3rd Street Improvements Jefferson Street to Blue Parkway
PROJECT NO. 575

ADDENDUM NO. 3

SHEET NO.	66	TOTAL SHEETS	204
DATE PREPARED	11/4/2024		
ROUTE	3RD ST	STATE	MO
COUNTY	JACKSON		
CITY	LEE'S SUMMIT		
PROJECT NO.	2020-575		
FEDERAL PROJECT NO.	TAP-3378(402)

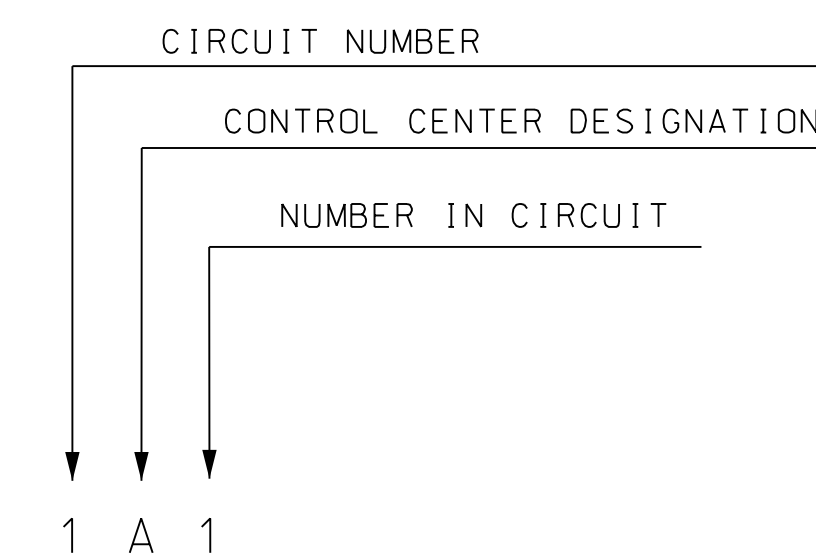
2. Sheet 66- Add Alternate A Quantities for the “Install 20’ Shepards Hook light Pole (See Details)” has been removed from the proposed work. The “Screw-In foundation for Light Poles” quantity was reduced from 13 to 11.

20' SHEPHERDS HOOK STREET LIGHT DETAIL

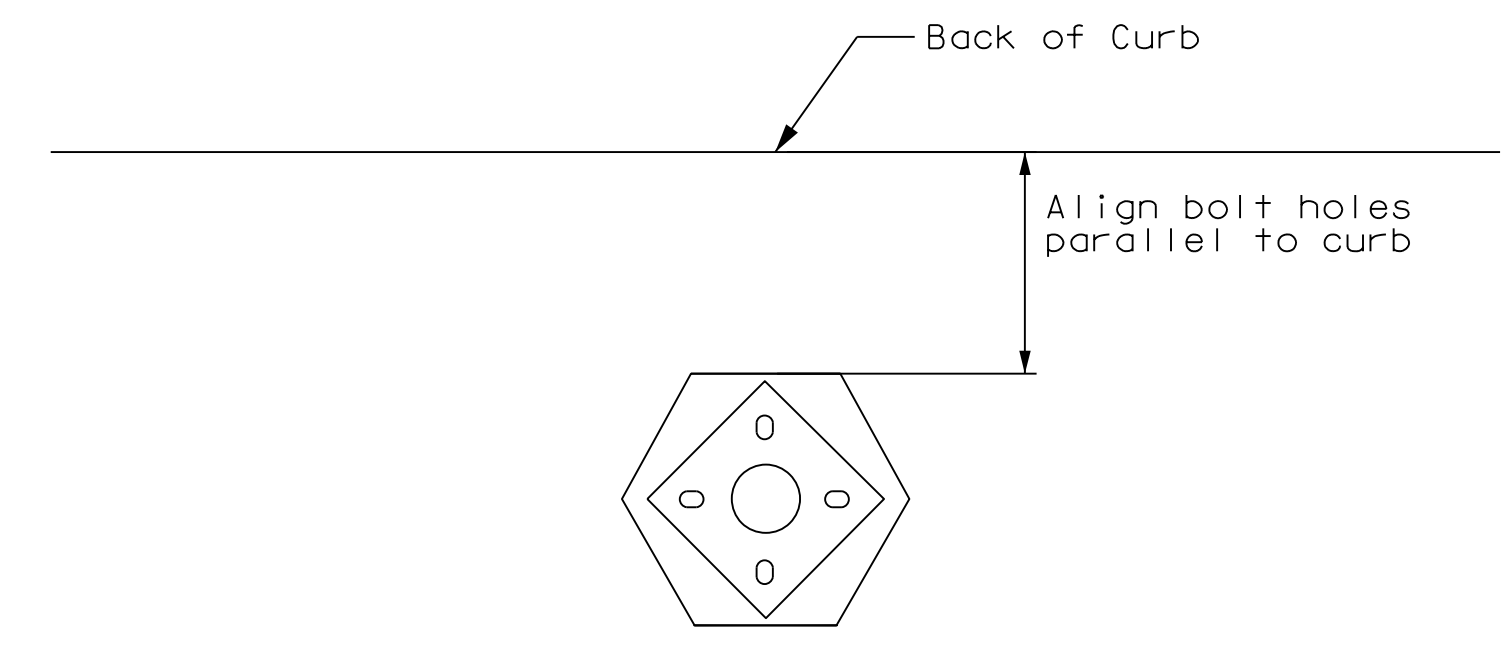
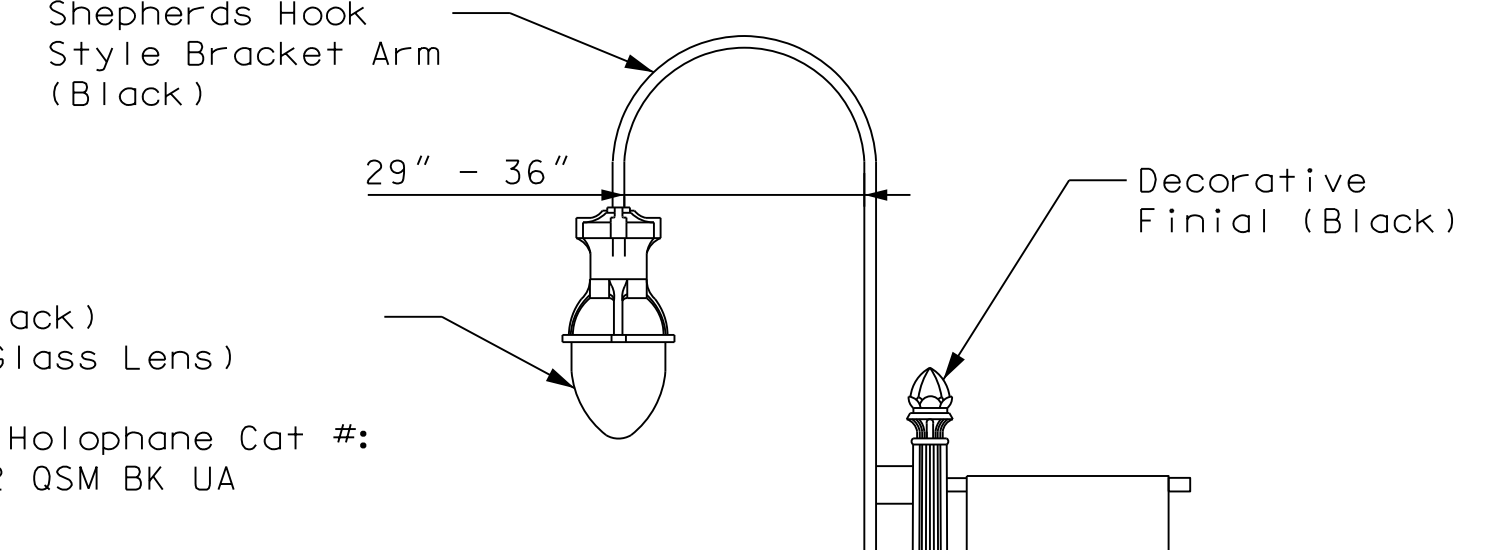
3. Sheet 67 – The dimension for the “Shepards Hook Style Bracket Arm (Block)” on the “20’ Shepards Hook Street Light Detail” has been changed from 36” to 29”-36”, and the clamshell base has been specified for different types of bases. Note: the Shepards Hook light will not be part of the proposed work at this time.

SHEET NO.	74	TOTAL SHEETS	204
DATE PREPARED	11/4/2024		
ROUTE	3RD ST	STATE	MO
COUNTY	JACKSON		
CITY	LEE'S SUMMIT		
PROJECT NO.	2020-575		
FEDERAL PROJECT NO.	TAP-3378(402)

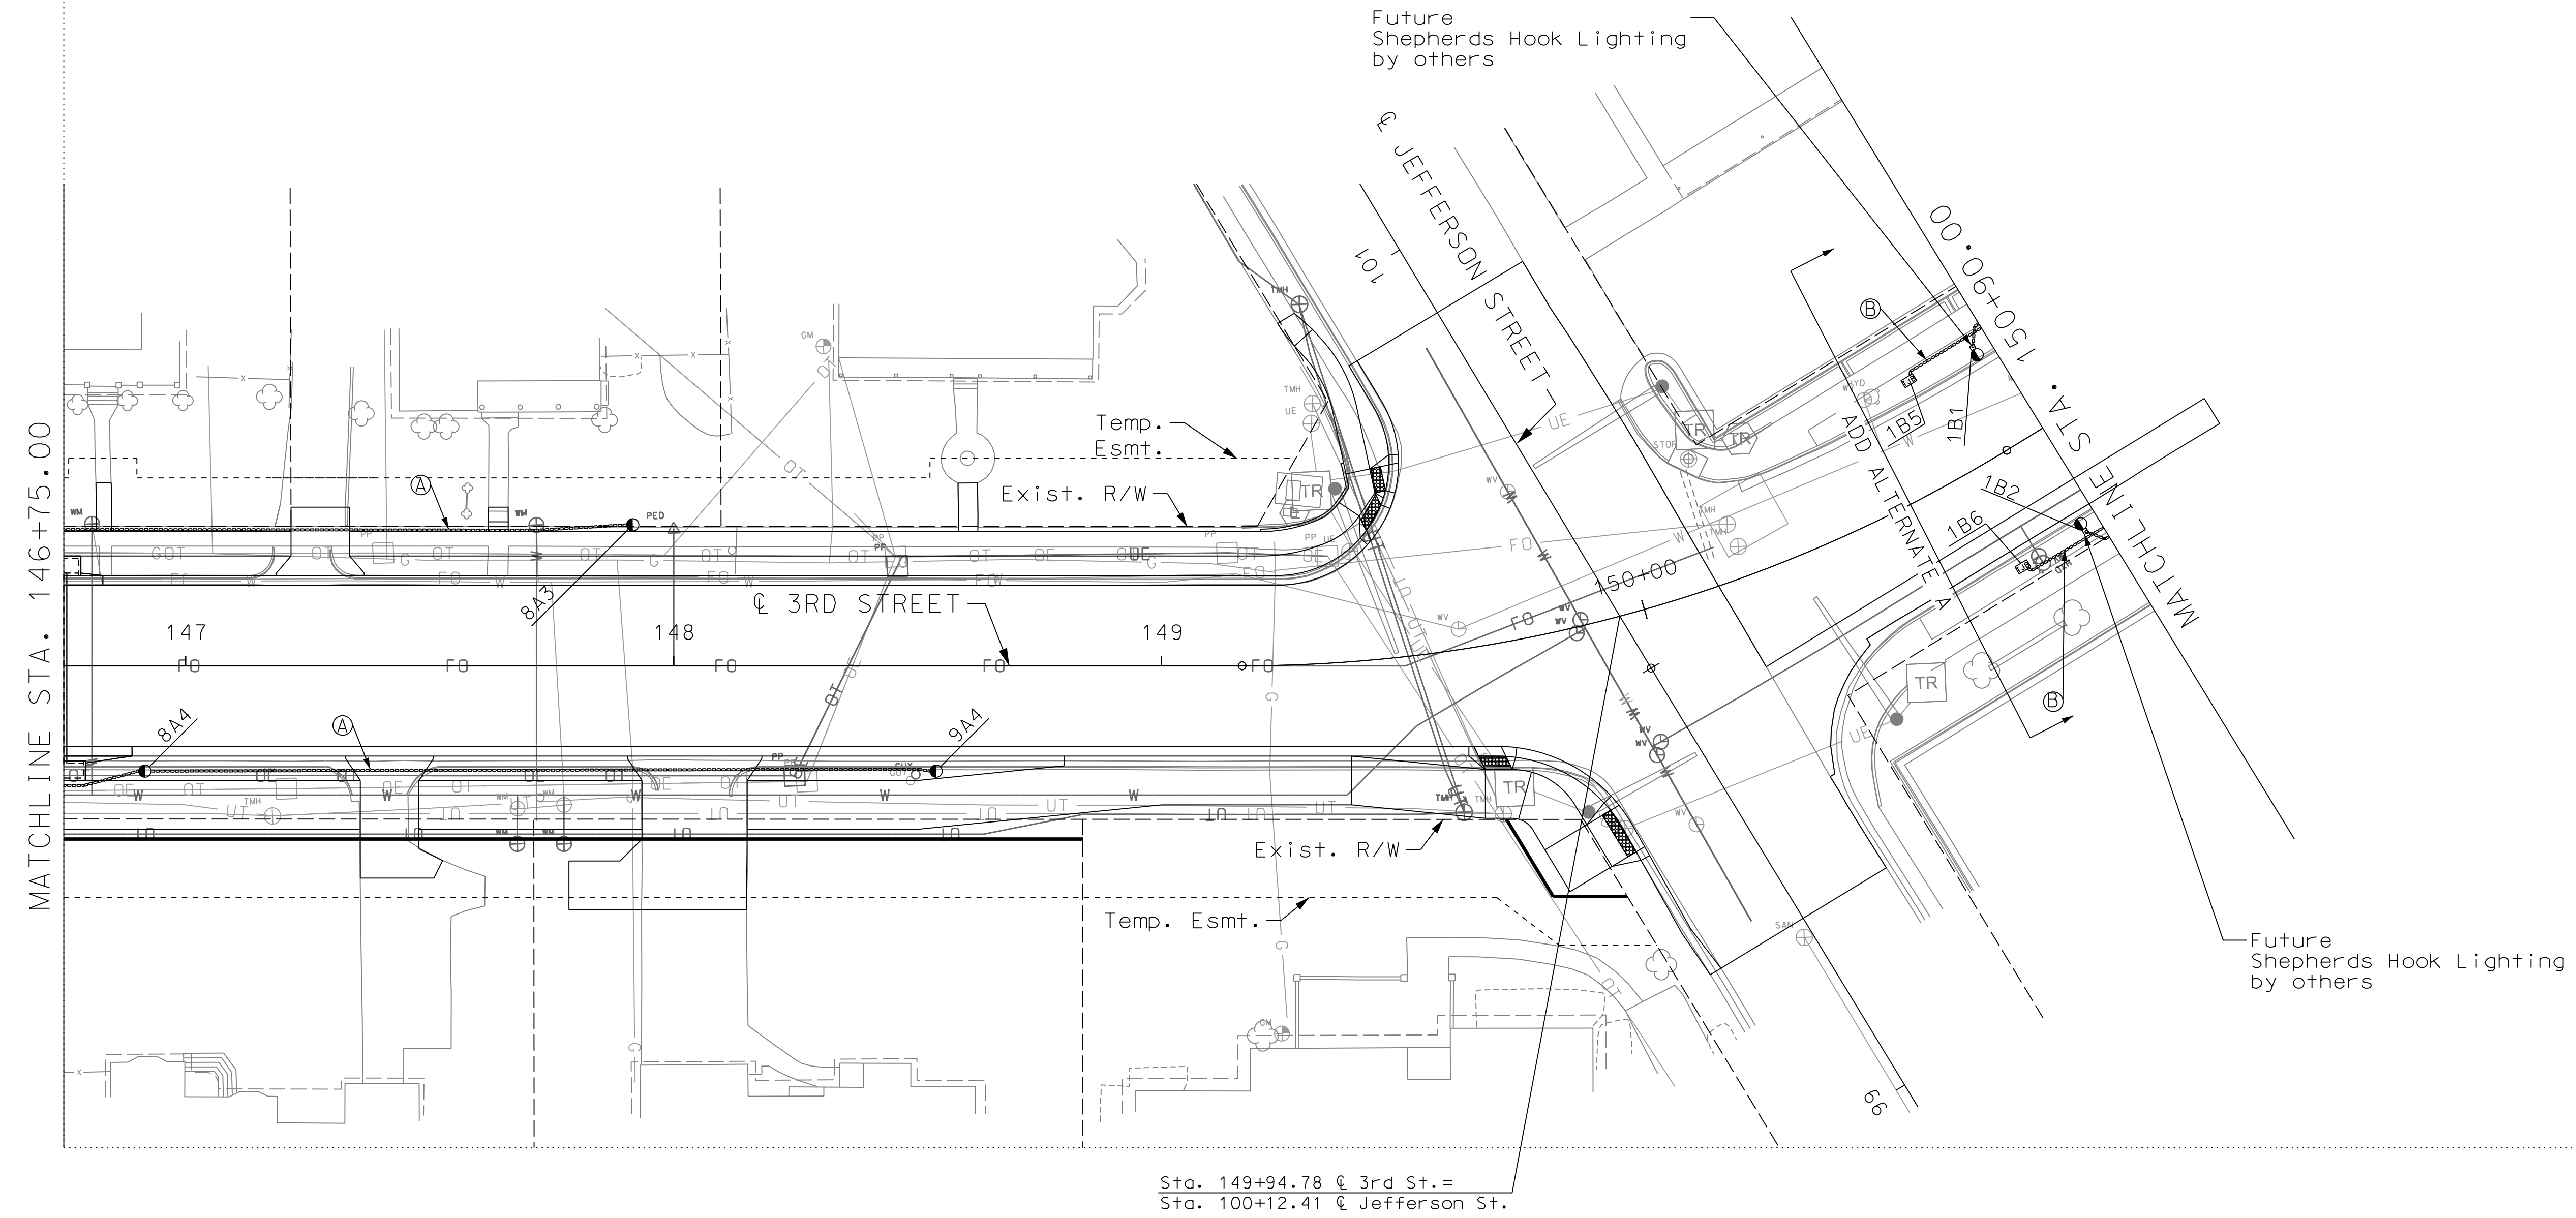
4. Sheet 74 – Light 1B1 & 1B2 have been changed to “Future Shepards Hook Lighting by others”.
5. Sheet 75 – Light 7B2 has been changed to “Relocated Shepards Hook Lighting”

-future light by others
 -future light by others

SHEET NO.	175	TOTAL SHEETS	204
DATE PREPARED	08/23/2024		
ROUTE	3RD ST	STATE	MO
COUNTY	JACKSON		
CITY	LEE'S SUMMIT		
PROJECT NO.	2020-575		
FEDERAL PROJECT NO.	TAP-3378(402)

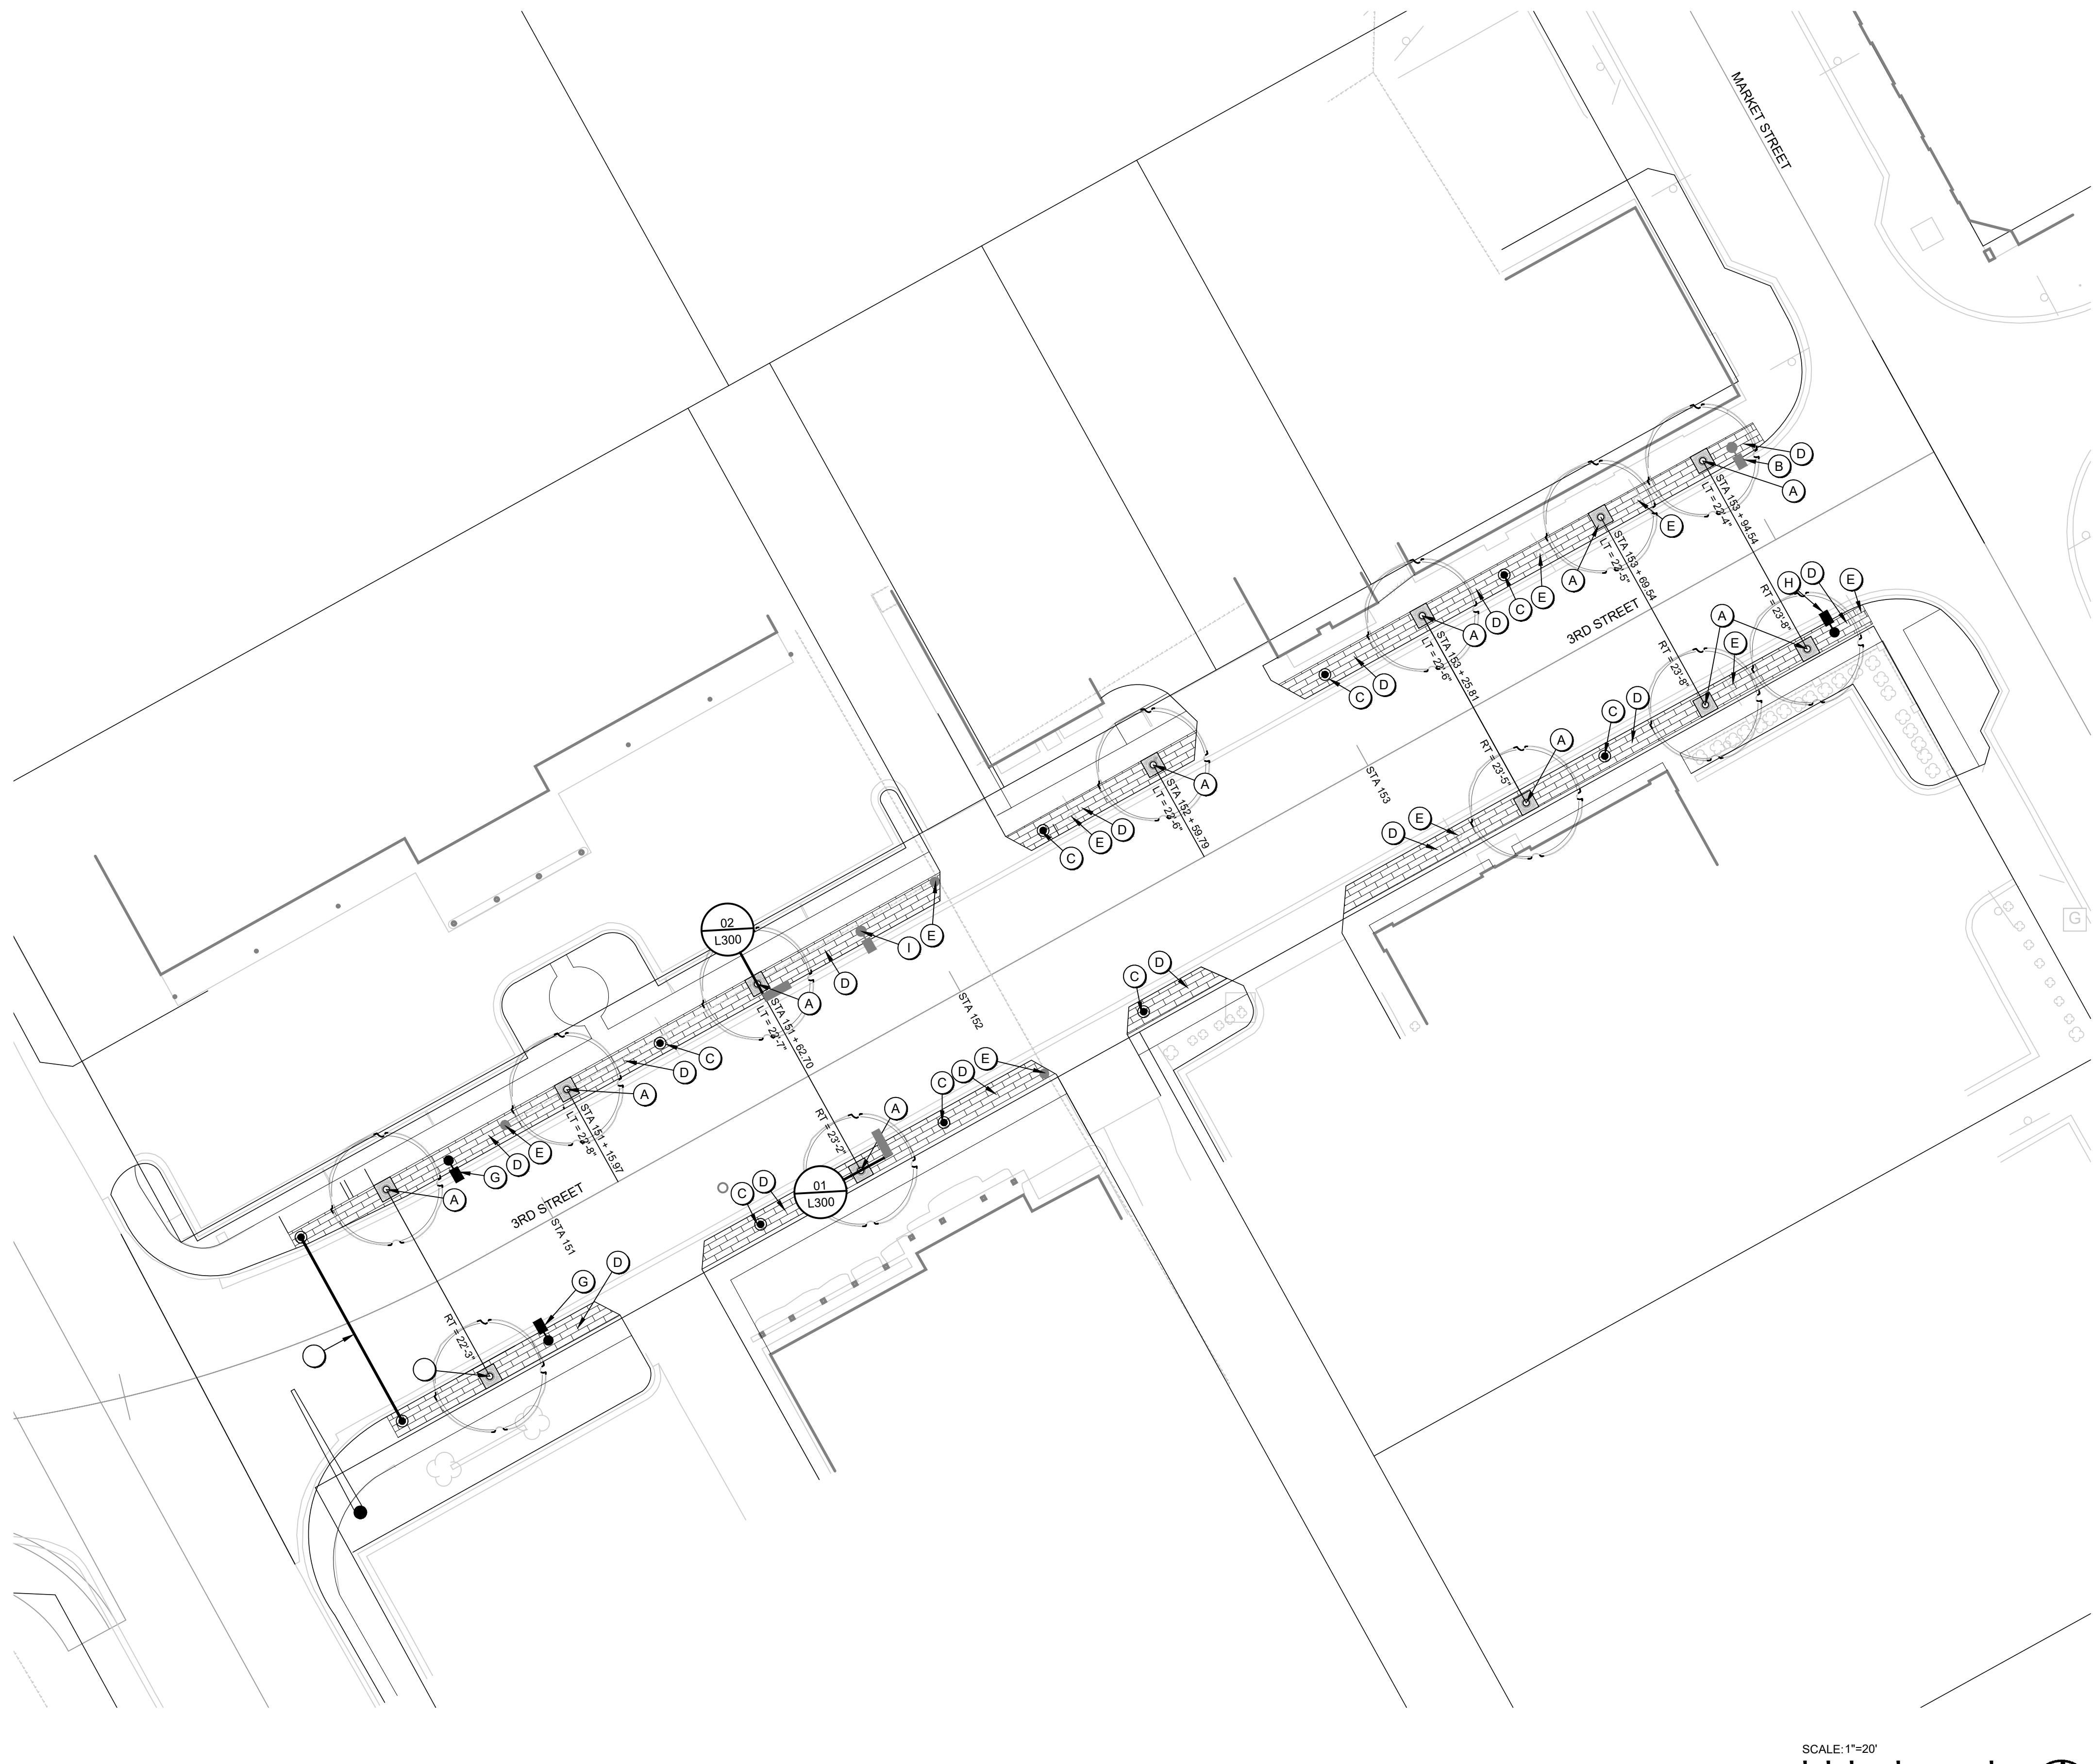
6. Sheet 175 & 176 – Item G in the legend was changed to “Future Shepard’s Hook (by Others)” and the changes on sheets 74 & 75 are reflected with changed callouts at those locations.
